# PlanGrid Task Report - Oct 9, 2024

13 tasks in this report.

**L05222\_Broadview FSU (IL)**

3300 Broadview Village Square, Riverside, Illinois

## #575 [UNIT 999][NEW] AC-3 economizer plug backwards from factory

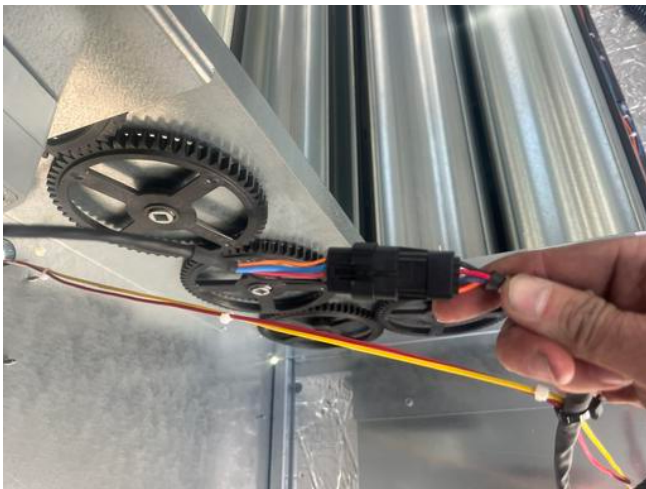
Economizer plug wired backward from factory. Corrected by NTAB. 25% open was 75% open.

Plug cannot be fully secured when rotated to correct orientation.

Recommend plug is secured

**#572 [UNIT 999][[NEW] (MISC) AC-3 : Return Humidity Sensor Not Installed**

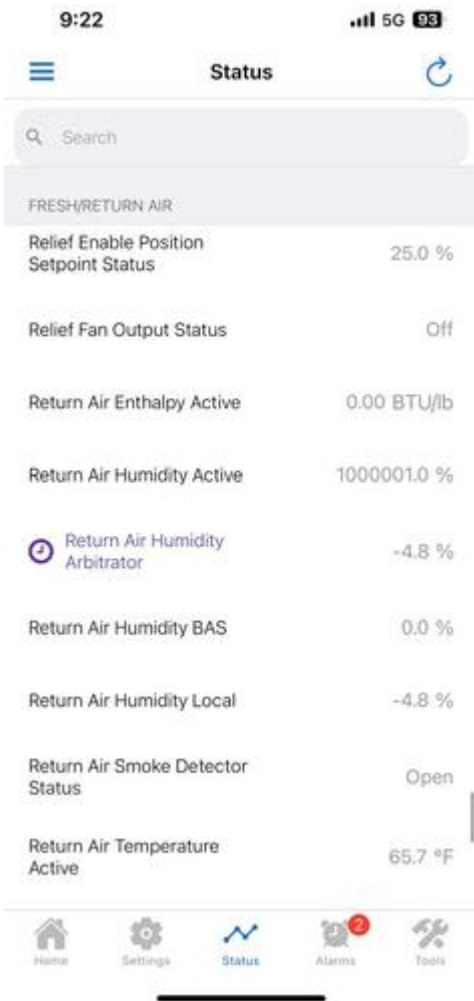
AC-3 is alarmed and does not appear to have a return humidity sensor installed. Recommend TRANE is consulted. This has occurred at multiple locations.
